Docket No. 50-373
Docket No. 50-374

We have received the attached Federal Emergency Management Agency (FEMA) letter dated July 1, 1985, and associated evaluation of the Alert and Notification System for LaSalle County Nuclear Generating Station in Seneca, Illinois.

The Federal Emergency Management Agency (FEMA) has completed an analysis of the prompt alert and notification system for the LaSalle Nuclear Power Station in Brookfield Township, Illinois. This review has been completed pursuant to FEMA rule 44 CFR 350; selected evaluative criteria and Appendix 3 in NUREG-0654/FEMA-REP-1, Rev. 1; and FEMA-43, the "Standard Guide for the Evaluation of Alert and Notification Systems for Nuclear Power Plants." The enclosed report entitled "LaSalle Nuclear Power Station Site-Specific Offsite Radiological Emergency Preparedness Alert and Notification System Quality Assurance Verification," summarizes the engineering design review, incorporates the results of the telephone survey of the public which was conducted immediately following the alert and notification system activation on December 4, 1984, and includes the results of the review of the other applicable evaluative criteria from NUREG

COMPARATIVE OSPM RESULTS, HILLY TERRAIN (FS 1000 SIREN)

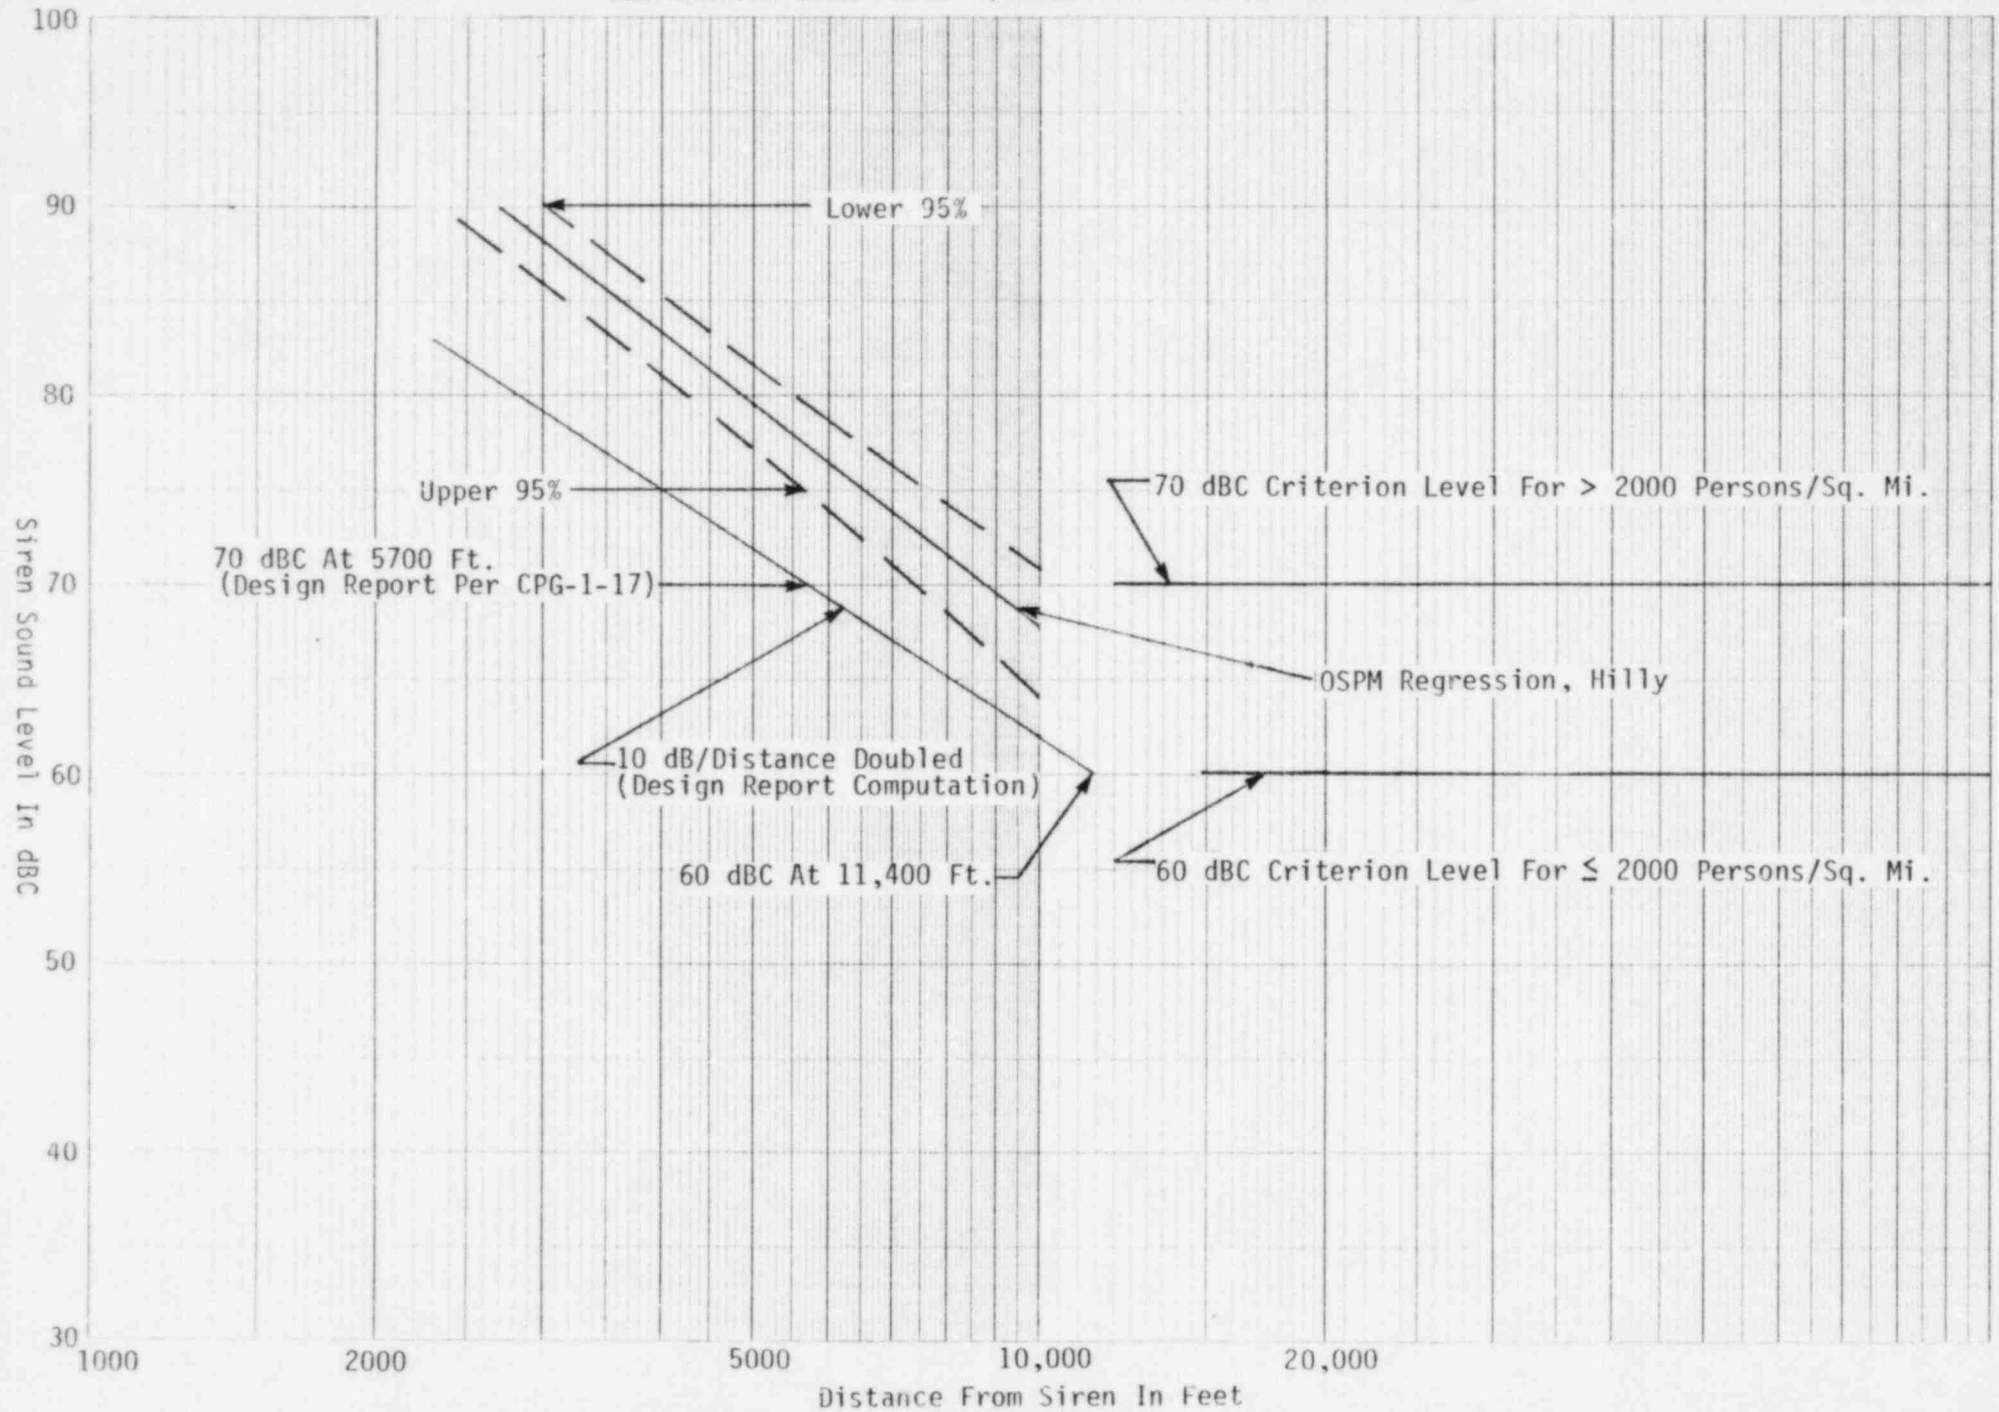
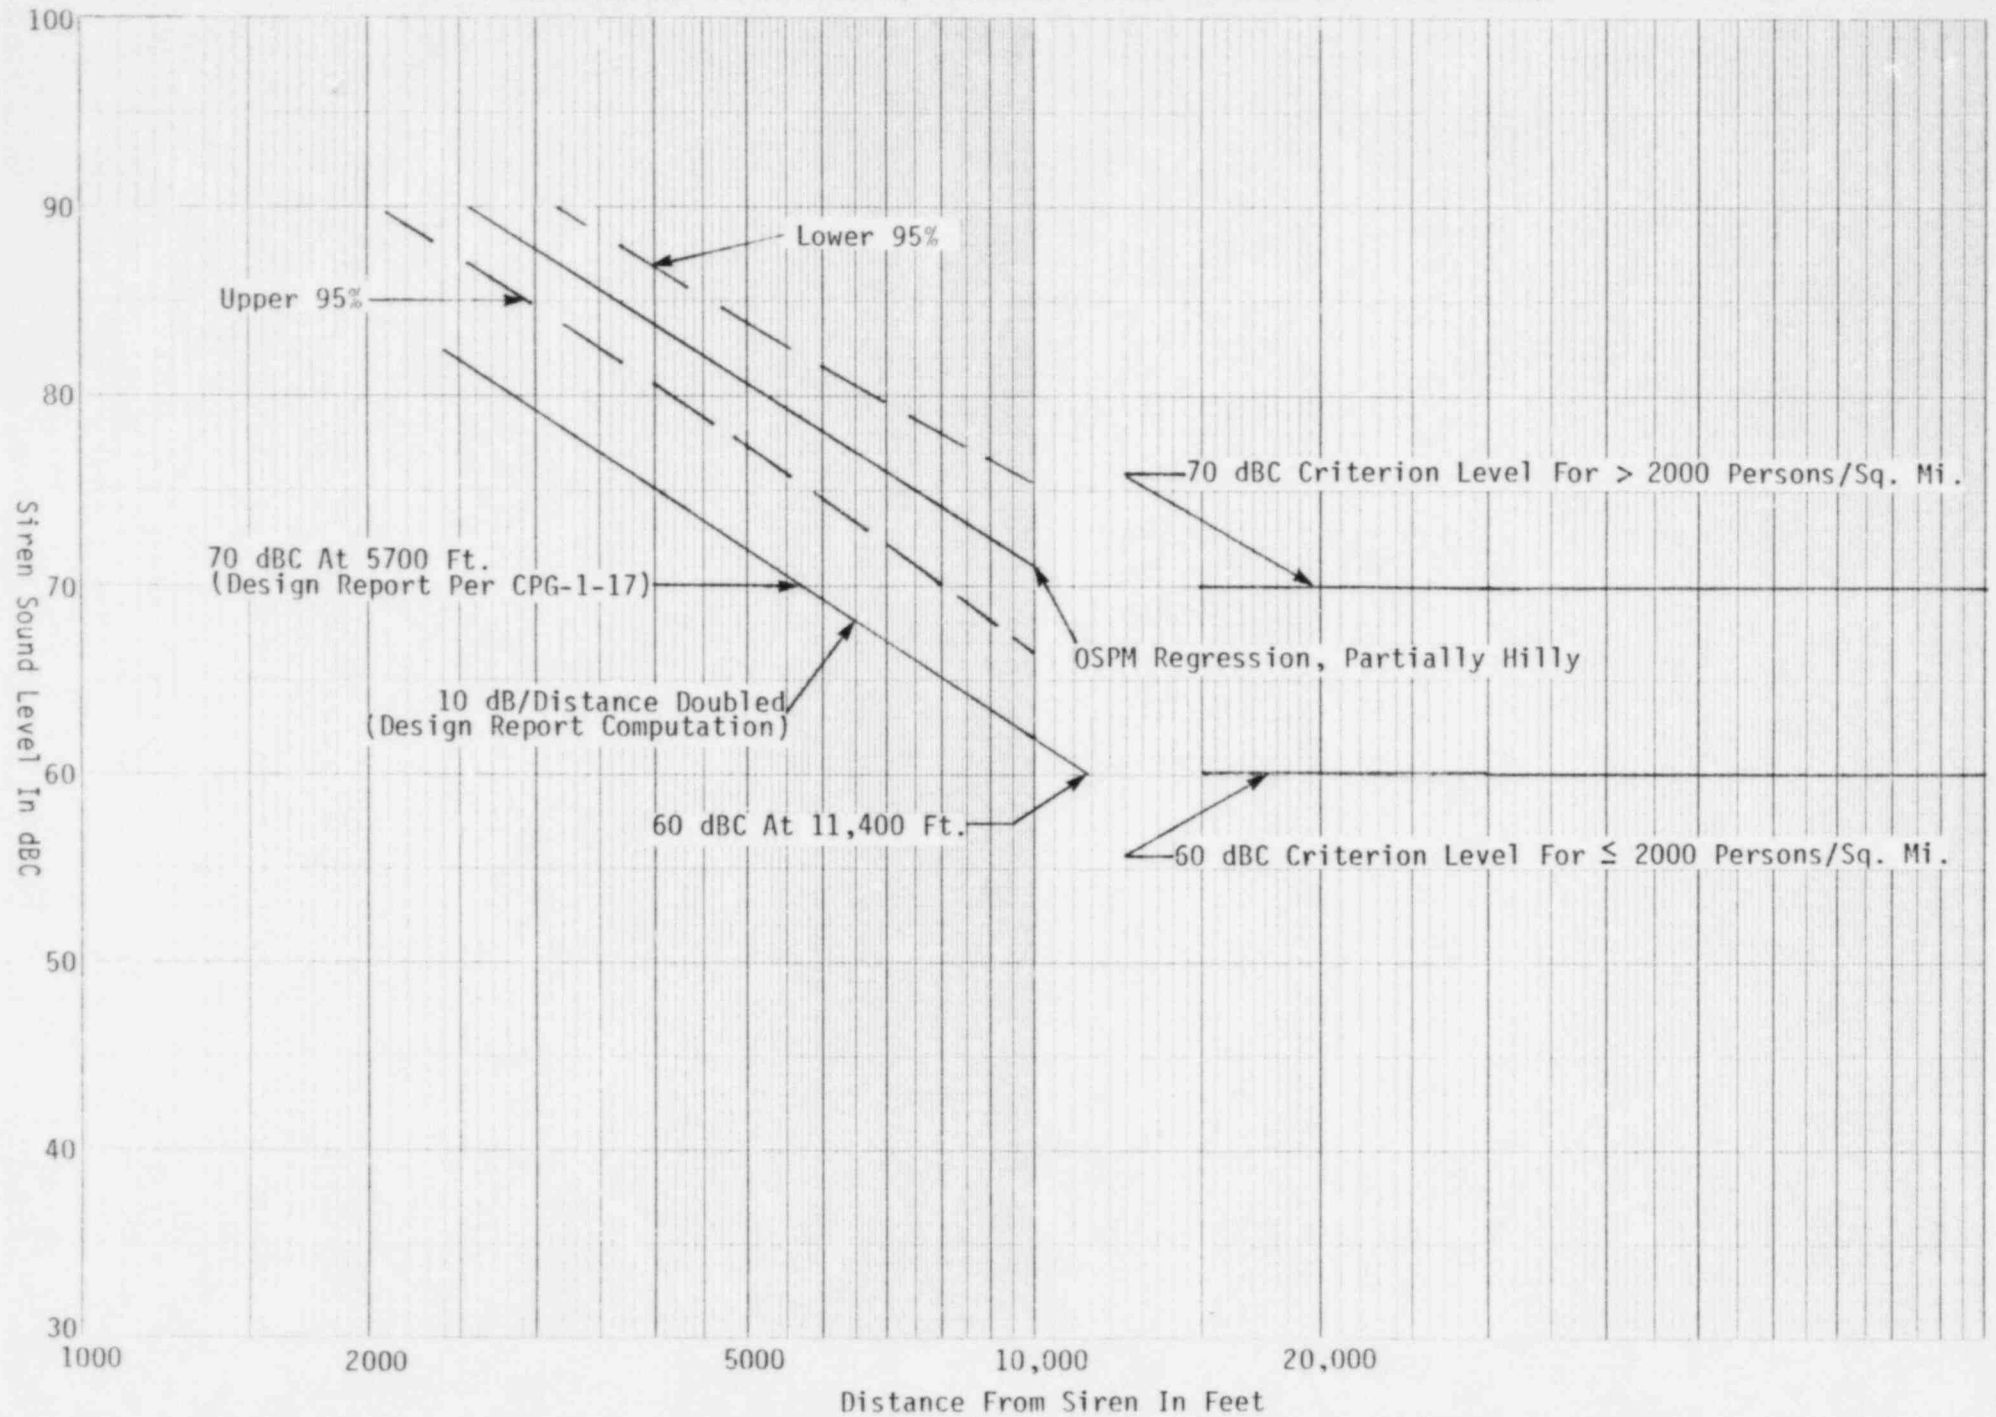
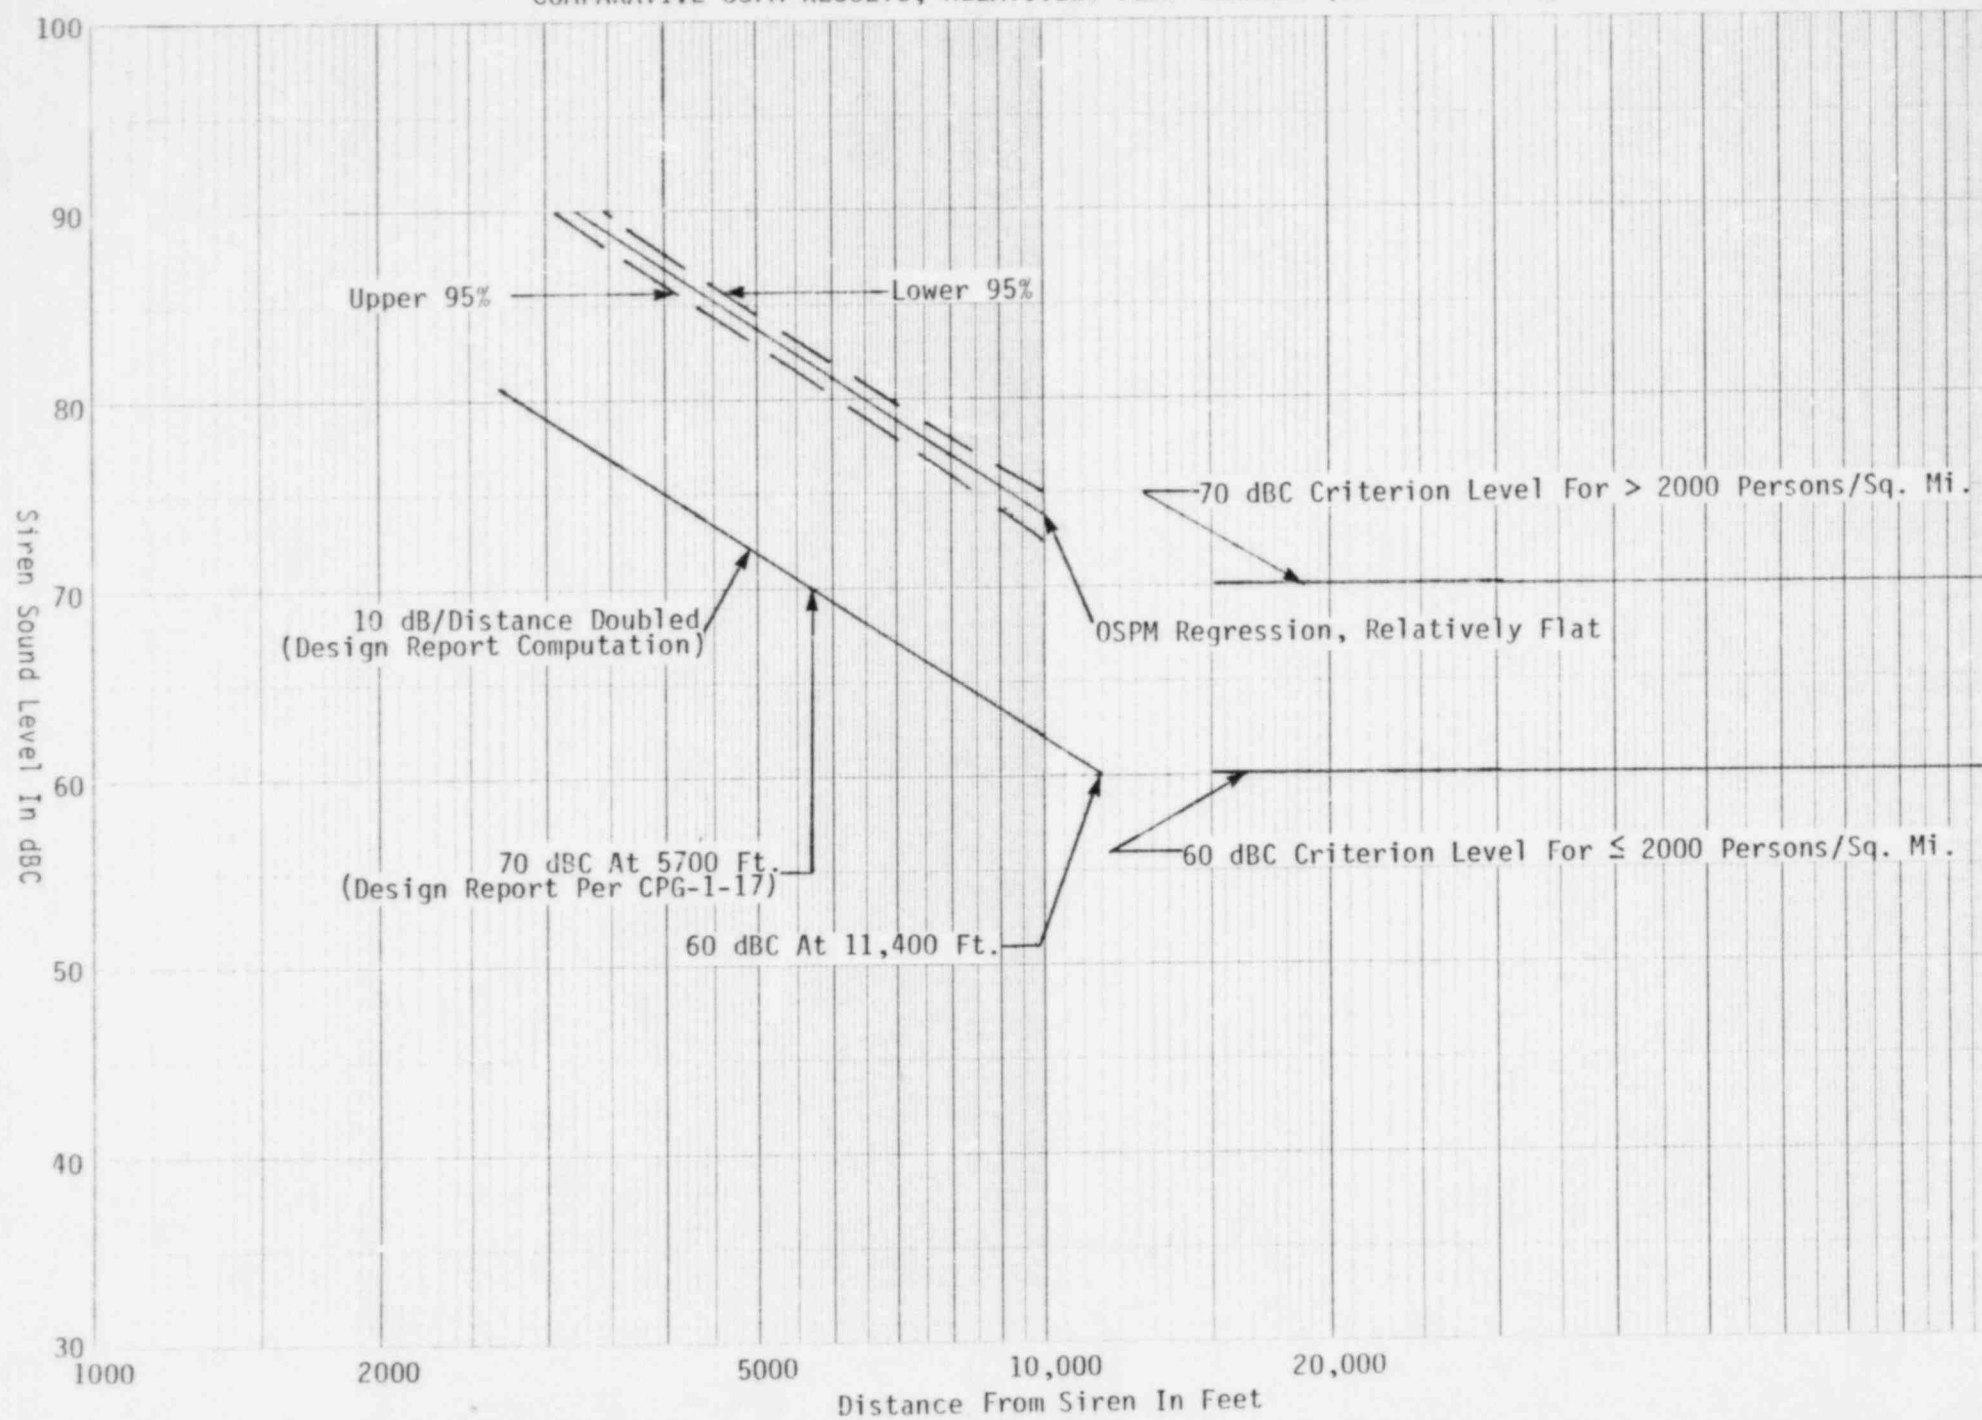
The OSPM results were classified, according to terrain profiles for each siren type, into three categories: hilly, partially hilly, and relatively flat. Regressions of dBC versus the logarithm of distance were performed for the FS 1000 and the FS STH10 sirens over each terrain category with the results depicted in Figures 3 through 8 of this report. The ranges of 70 dBC and 60 dBC as calculated in the Design Report without considering terrain barrier or two-siren additive effects are also shown on the figures and summarized below:

Siren Type	70 dBC (ft)	60 dBC (ft)
FS 1000	5700	11,400
FS STH10	1890	3780
FS Model 2	690	1380
FS LCS	-	740

These ranges are conservative over relatively flat terrains, with the conservatism being pronounced for the 70 dBC range estimates. In addition, the range estimates that include the barrier attenuation procedure over partially hilly and hilly terrains adequately account for the site terrain characteristics.
